TOWN PLANNER QUESTIONS, COMMENTS AND RECOMMENDATIONS #2**From:** Conor McCormack, Director of Planning & Development**To:** Millbury Board of Appeals

17 Rice Road

Application: Ch. 40B Comprehensive Permit
Applicant: SJV Investments, LLC
Location: 17 Rice Road
Map 63; Lots 75, 75A, 75B, 75C & 144
Application Submitted: October 31, 2023
Legal Ad Publication Dates: November 9, 2023 & November 16, 2023
Public Hearing Scheduled: November 29, 2023

Comments based on the site plan entitled “*Rice Pond Village Site Plan of Land in Millbury, MA*”, dated October 24, 2023, revised December 29, 2023, prepared by Azimuth Land Design, LLC, and Applicant response letter to Planning Staff comments, dated December 29, 2023.

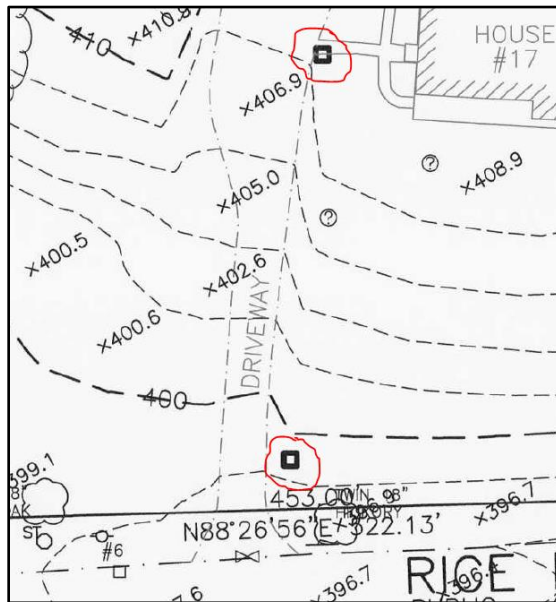
- i. Section 3.13.3.8 – Can the Applicant clarify the purpose of the questions mark symbol shown on the plan:

The Applicant noted they still need to clarify or change the representation of those symbols on the plan. Also requesting clarification on this symbol:

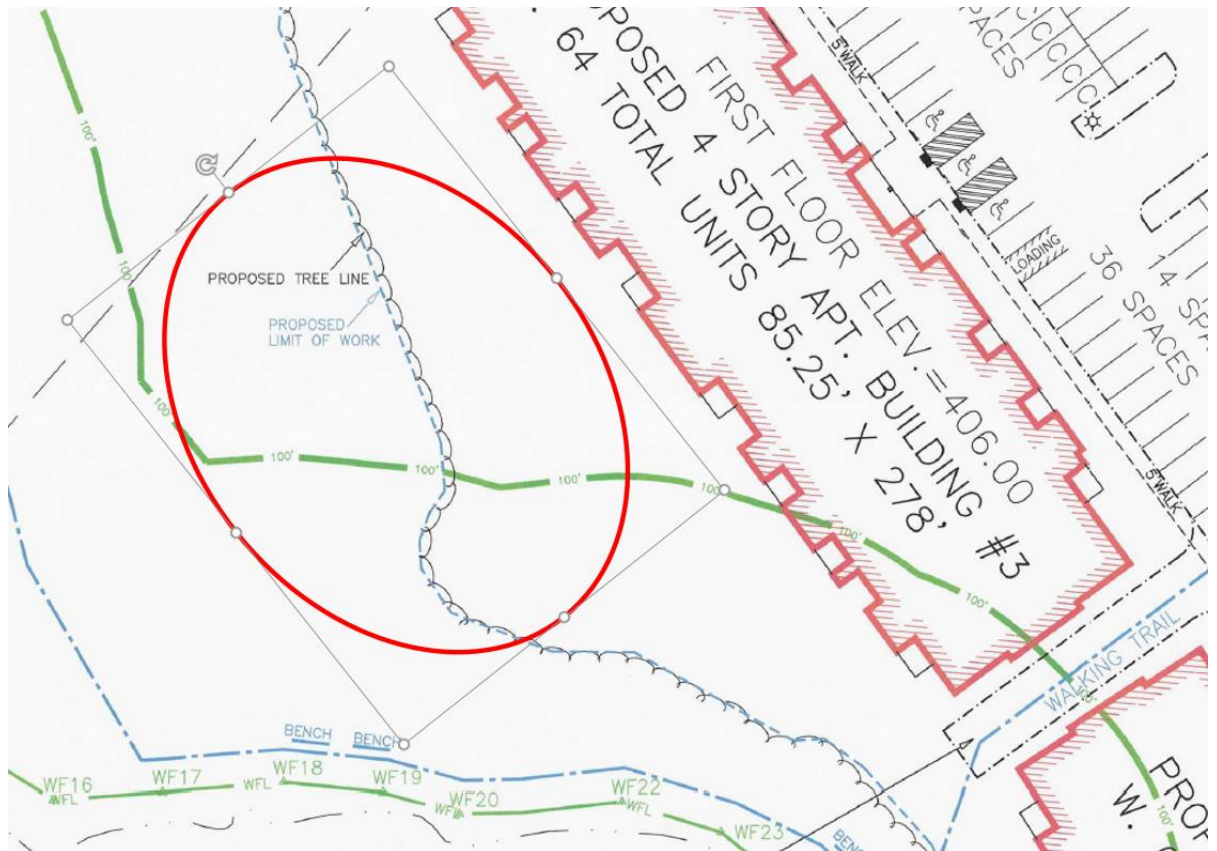
While the Ch. 40B process provides for the Applicant to bypass some local zoning restrictions that inhibit the construction of low to moderate-income housing, the Board should look for opportunities to negotiate with the Applicant to reduce the scale and size of the project, while not making the project uneconomic. Examples could include a reduction in the total number of units; lowering the total building height/number of stories; setting the top floor of the building back or introducing a mansard roof style top floor to reduce the massing/appearance of the building; shifting the location of the building away from abutters; or providing more building at lower heights.

In particular, the Board may consider whether there is an opportunity to advocate for a flat roof over a pitched roof, which may could result in a significantly lower overall building height and reduce the visual massing of the buildings.

The Applicant noted that they do not intend for significant changes to the project scope. The Board may still want to look at opportunities to work with the Applicant on the project size, height, massing, density, etc. to make the project better fit into the existing character of the neighborhood.

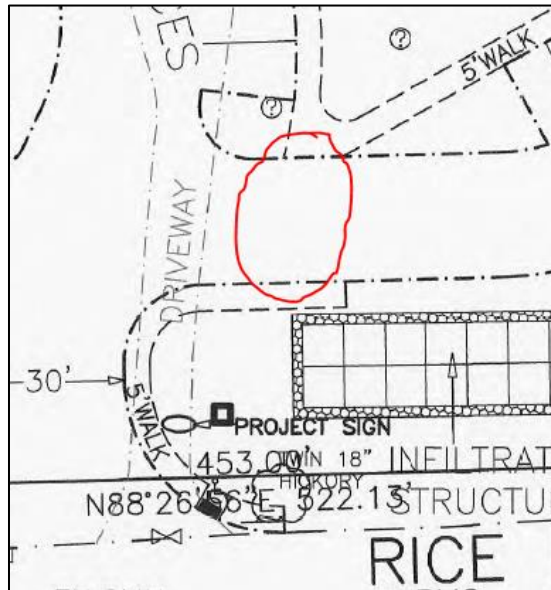
- d. Section 3.13.5.5 – Sheet D2 shows a detail for a guardrail but a guardrail does not appear on the site layout sheets. Please identify the location of the guardrail on the site plan.

This comment has been addressed.
